ADDENDUM NO. 1

JAY COUNTY BRIDGE NO. 139 ON
SEVENTH STREET OVER SALAMONIE RIVER
JAY COUNTY, INDIANA

Revisions to Jay 139 Contract Documents

HORIZONTAL SCALE	BRIDGE FILE
1" = 5'	JAY 139
VERTICAL SCALE	DESIGNATION
1" = 5'	
DRAWING NO.	SHEETS
	35A of 37
CONTRACT	PROJECT
	091024

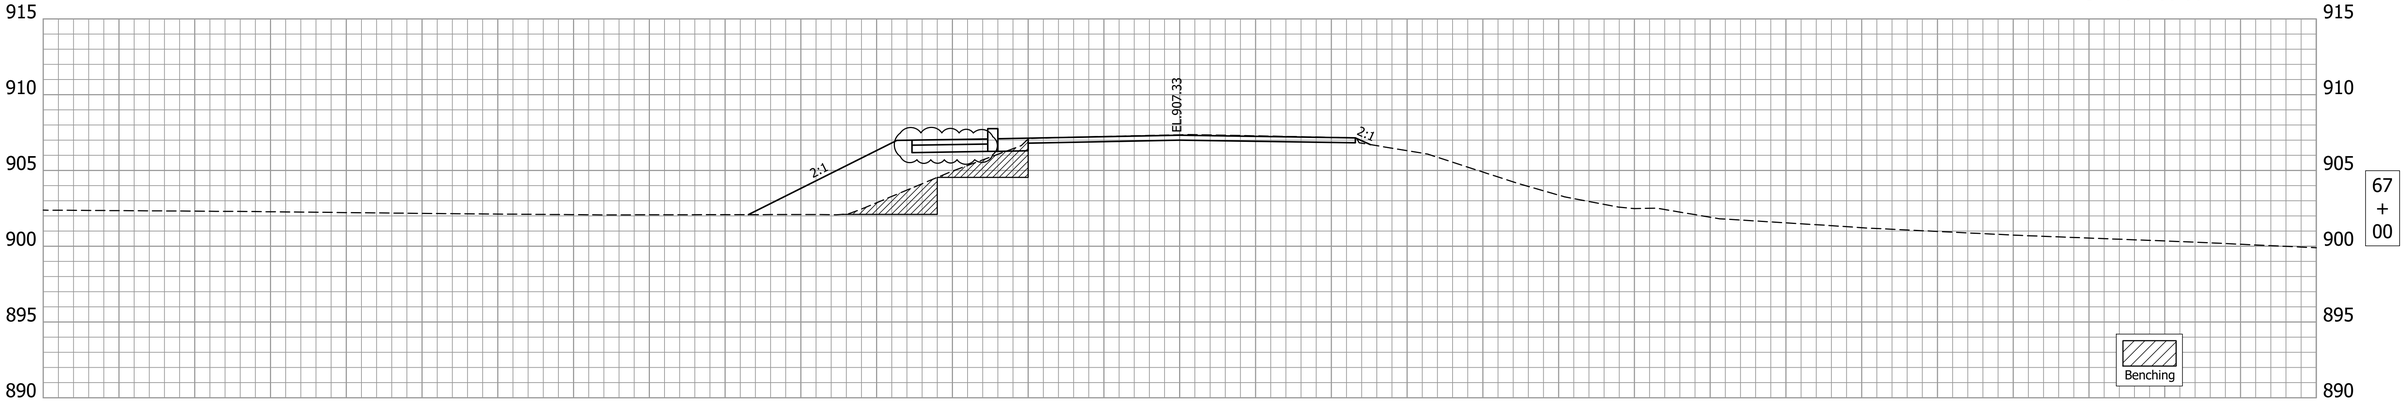
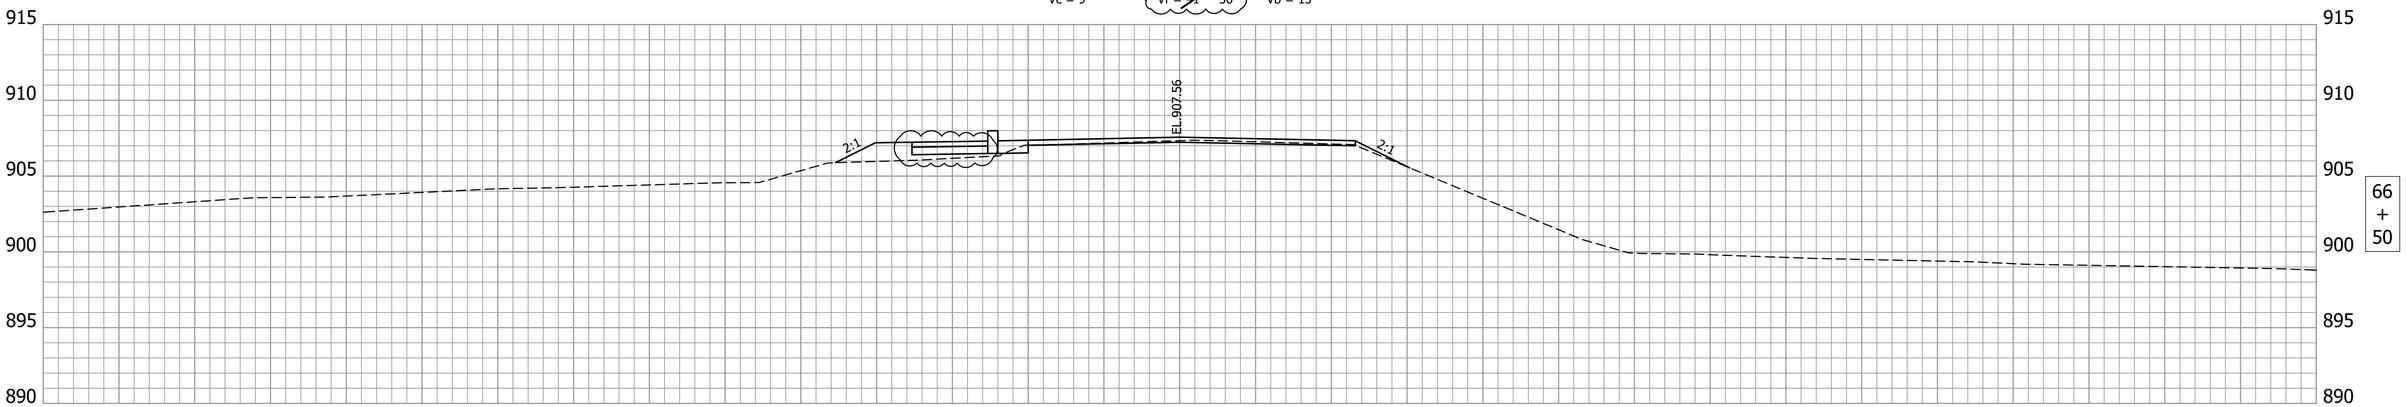
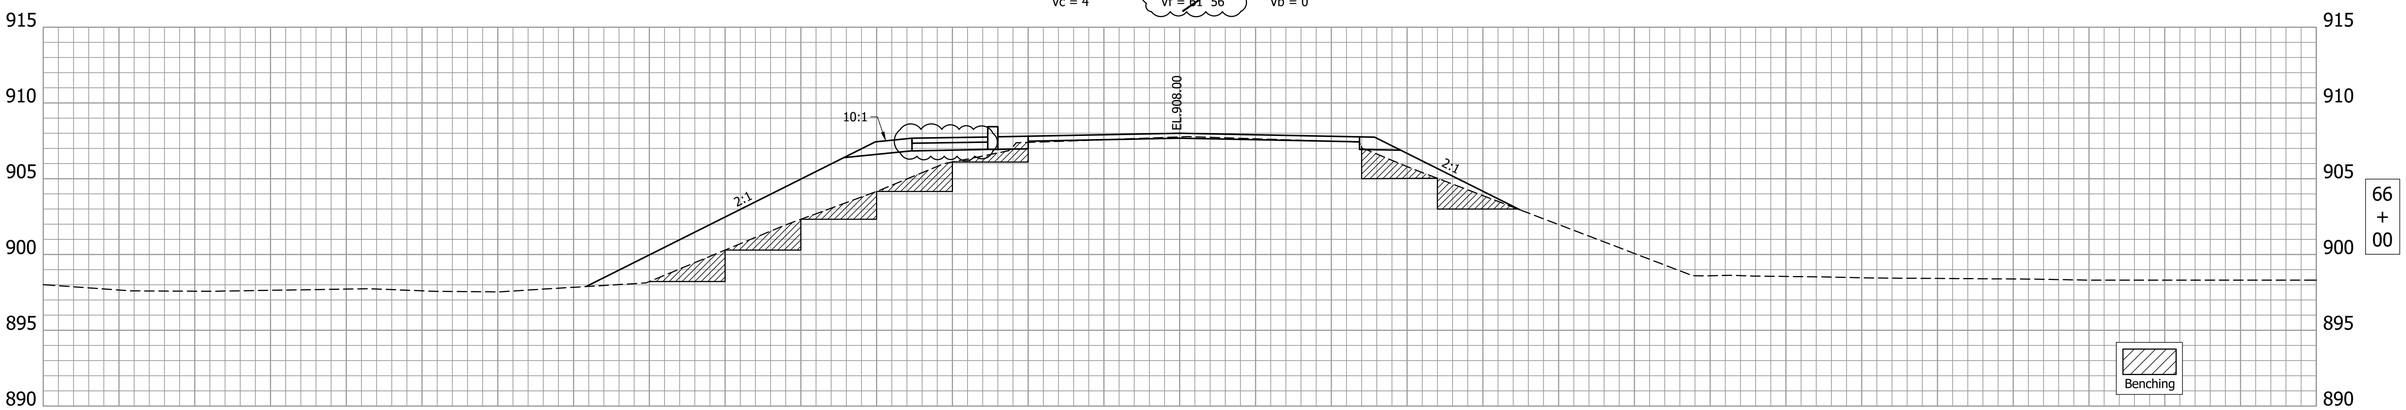
Af = ~~34.8~~ 32.4
Vf = ~~41~~ 36

Af = ~~9.2~~ 6.7
Vf = ~~61~~ 56

Af = ~~56.6~~ 54.1
Vf = ~~109~~ 105

4/9/2025 Revised Earthwork Quantities

HORIZONTAL SCALE	BRIDGE FILE
1" = 5'	JAY 139
VERTICAL SCALE	DESIGNATION
1" = 5'	
DRAWING NO.	SHEETS
	37A of 37
CONTRACT	PROJECT
	091024

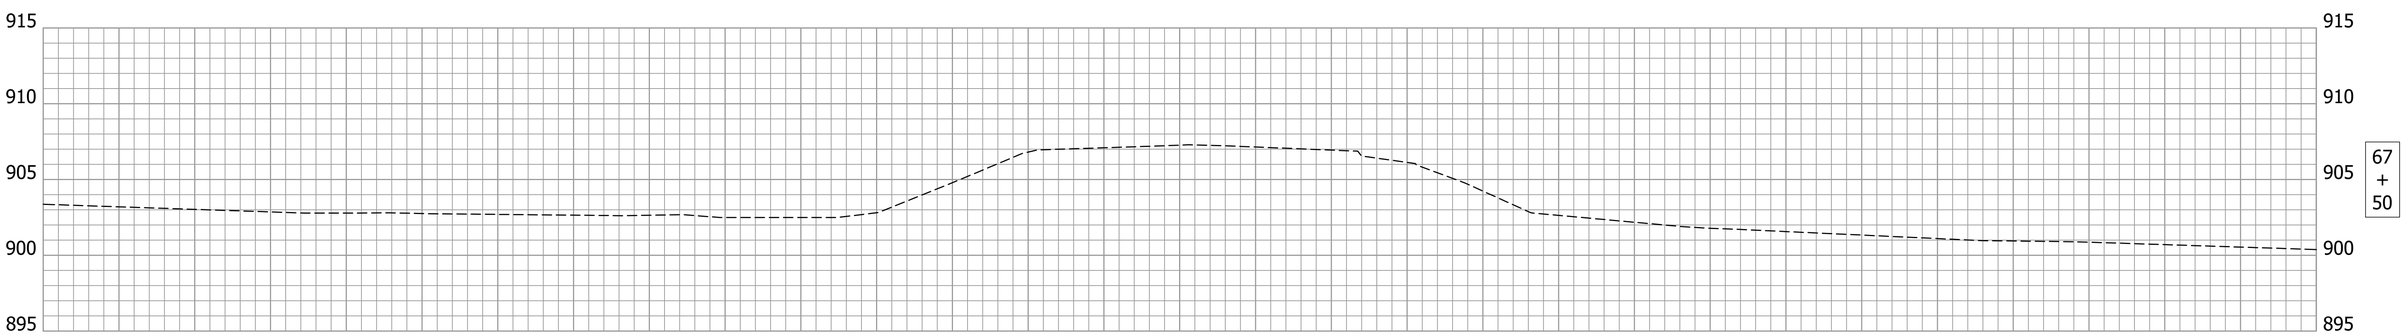
Ac = 0.0 Af = 0.0 Ab = 0.0
Vc = ~~7~~ 8 Vf = ~~32~~ 30 Vb = 13

4/9/2025 Revised Earthwork Quantities
